# Response to Professor Paul Younger (SC20) and Professor Andrew Aplin (RC1) on Fylde groundwater salinity

David Smythe

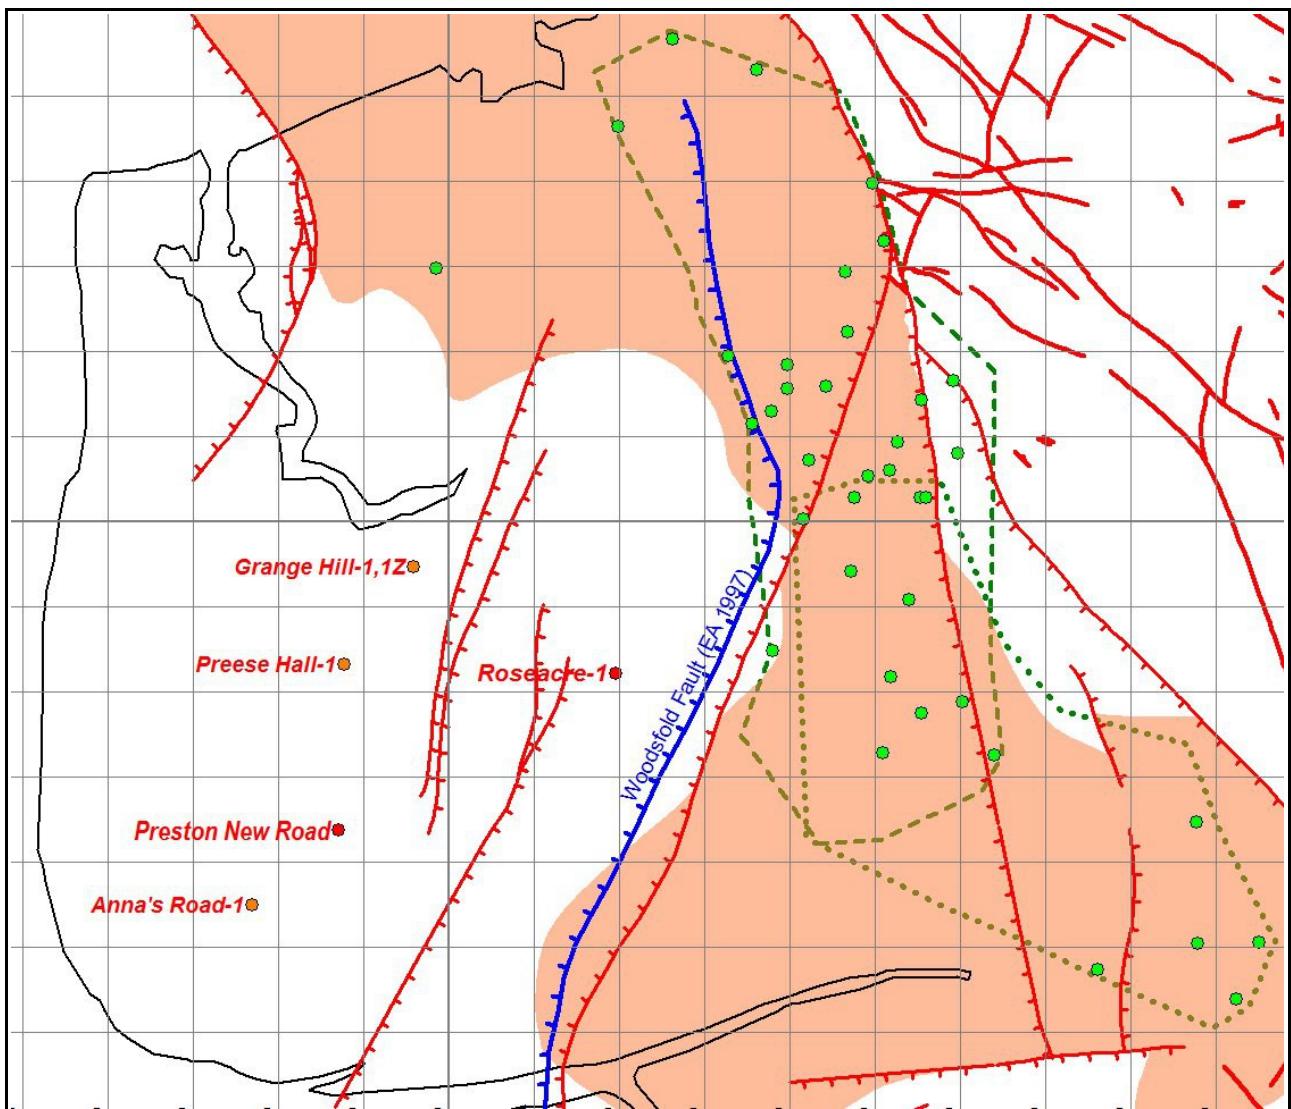
**Brereton and Skinner 1974.** I do not have access to this paper, but it is discussed in Sage and Lloyd (1978) and Tellam and Barker (2006), both of which I have consulted. All three papers confine their attention to the SSG aquifer at outcrop east of the Woodsfold Fault (Fig. 1).

**Barker and Worthington 1973a, 1973b; Worthington 1977.** I have now downloaded the first two of these papers, to confirm their non-relevance to the issue; the last I had downloaded on 4 February 2014. All three papers discuss the physical properties of the SSG. Figure 1 in each shows that all the samples come from the outcrop east of the Woodsfold Fault. These papers are cited in

Tellam and Barker (2006). The green dashed line (Fig. 1) encompasses all the boreholes discussed by Worthington (1977).

All nine of the citations that Professor Younger accuses me of neglecting are either irrelevant and/or outdated. I was previously aware of five of them; I have downloaded two more to confirm their irrelevance, as suspected, and the two remaining, over 40 years old, have been superseded by later work. **None of the work cited by Professor Younger has any bearing on the hydrogeology of the western Fylde, west of the Woodsfold Fault (Fig. 1).** They all concern the SSG aquifer at outcrop. To demonstrate this I have plotted on Figure 1 two green-bordered polygons, each showing the areas encompassed by the boreholes studied in Worthington (1977) – dashed line, and Seymour et al. (2006) – dotted line.
